**NHTSA Safety Recall 24V-742**

**TO: Winnebago Motorhome Dealers**  
**SUBJECT: Campaign # 190 – Seat Belt Retractor**

# View/Navion Seat Belt Retractor Rework – Recall #190:

Image 2

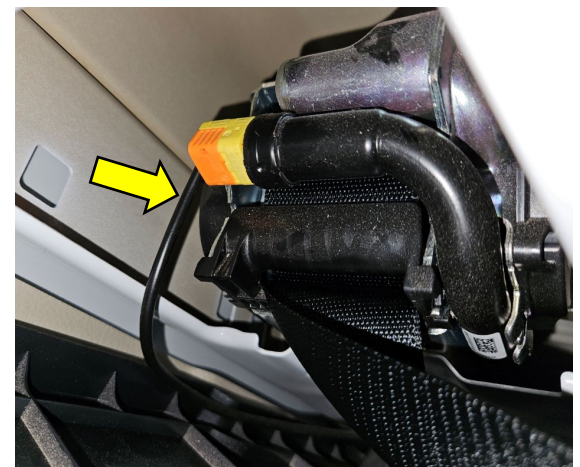
1. Gain access to the inside of the Chassis B Pillar for inspection. Follow these instructions for both Driver and Passenger side.
  - a. Locate and remove the rubber cover from the coat hook at the top of the B Pillar.
  - b. Remove the mounting bracket underneath the rubber cover using a T20 Torx Bit. See Image 1.
  - c. Using plastic trim tools as necessary, pull the B Pillar cover away from the B Pillar starting from the top. See Image 2. Only pull the plastic away far enough to see the face of the seat belt retractor closest to the wingwall. See Image 3.
    - I. **Note:** Do not remove the bolt attaching the bottom of the seat belt to the B pillar.
    - II. **Note:** Be careful when pulling the B Pillar plastic away as excess bending could damage the cover.

Image 2

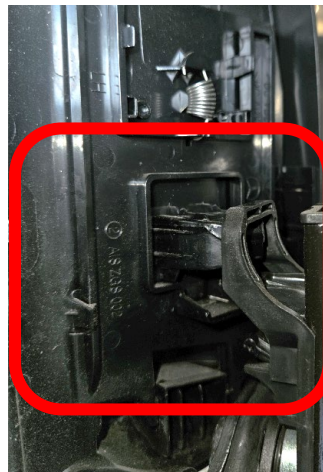
2. With the B Pillar cover now pulled away, Inspect the retractor. Ensure on the wingwall side that no screws have contacted the retractor. See Image 1 for an example of a screw impacting the retractor.
3. **If any screws tip has contacted the retractor, follow the rest of the rework instructions. Only rework the side of the coach that had a screw impact the retractor.**
4. **If no screws have contacted the retractor, then the unit does not need to be reworked.**
5. If the coach does not require rework, reinstall the B Pillar cover.
  - a. **Note:** When reinstalling the B Pillar cover, ensure that the tab on the B pillar cover is in alignment with the mating connection on the B pillar. See Image 2. Confirm alignment after reinstallation of the cover by actuating the seat belt height adjustment. See Image 3.

Image 2

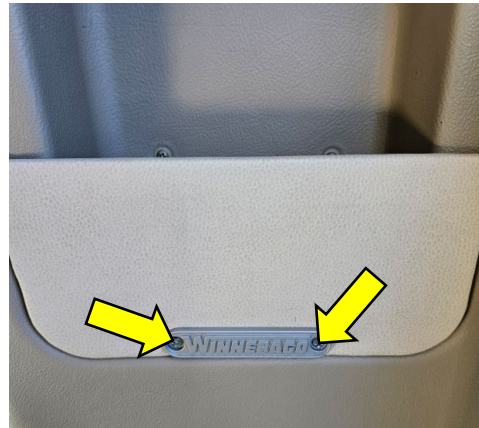
1. If a screw has contacted the retractor, follow the proceeding steps for the side identified.
2. For the driver side only, extend the slideout.
3. For the passenger side only, remove the fire extinguisher and its mounting bracket from the wingwall cover. See Image 1.
4. For either side, remove the soft covers from the pockets of the Wingwall cover.
  1. Remove the Winnebago nameplate at the bottom of the pocket. See Image 2.
  2. Push up and out on the soft cover to disengage the metal clips from the Wingwall Cover. See Image 3.

Image 1

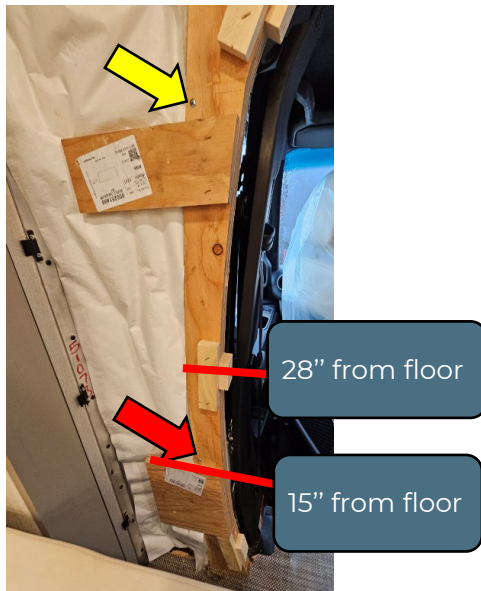
1. A wooden structure should now be visible, this is the transition panel asm.
2. Remove the panel asm from the Wingwall by removing the mounting screws securing it. See Image 1.
3. Mark out an area around retractor by measuring 15 inches from the bottom edge of the wooden structure up to 28 inches from the bottom edge. This area should not have pilot holes drilled into it.
4. Mark the existing screw holes as incorrect if they fall within this area. See Image 1 Red Arrow for an example of a screw in the incorrect zone.
5. Using the drill and 5/32" bit, drill new pilot holes in the areas identified in Image 2 and 3. Driver side shown, mirror these locations for the passenger side.

Image 1

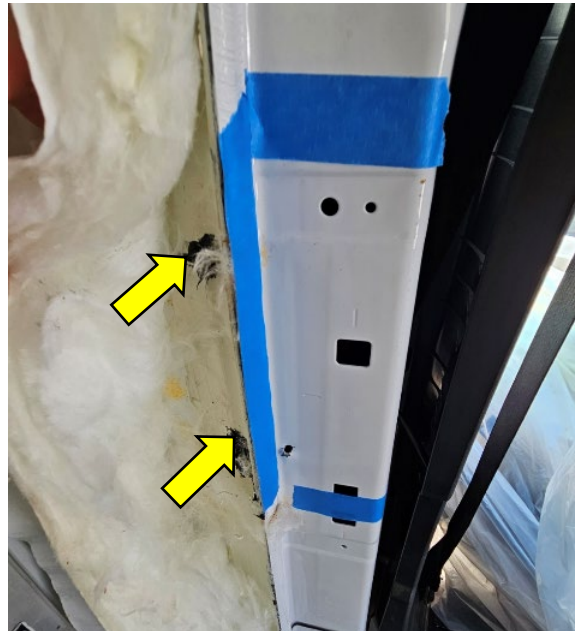
1. Measure out and mark an area around retractor from 15 inches from the coach floor up to 28 inches from the coach floor.
2. Locate screws under the insulation on the outside of the pinch weld on the B pillar, they will be covered by sealant.
3. If any screws are within the marked area, remove the screws. See Image 1 for an example from the driver's side.
4. Cover the empty screw holes with sealant and replace the insulation after the sealant has set up. See Image 1.

Image 1

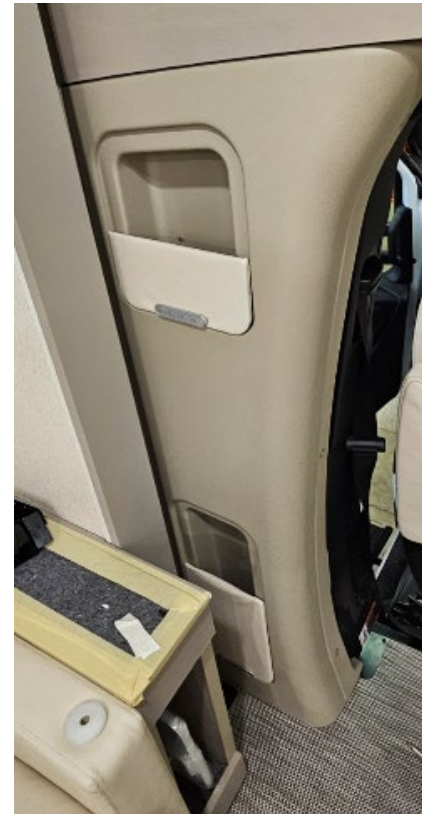
1. Reinstall the Transition Panel Asm using the supplied mounting screws. See Image 1.
2. Reinstall the Wingwall Cover and related components using the existing mounting screws. See Image 2.

Image 1

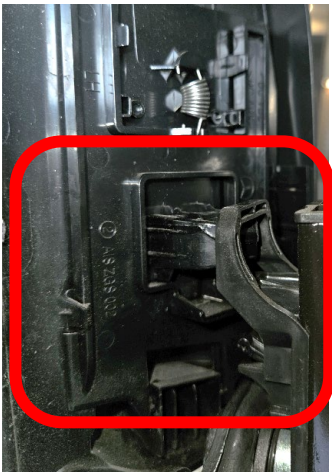
2. Reinstall the B Pillar cover.
  - a. Note:** When reinstalling the B Pillar cover, ensure that the tab on the B pillar cover is in alignment with the mating connection on the B pillar, See Image 1. Confirm alignment after reinstallation of the cover by actuating the seat belt height adjustment. See Image 2.
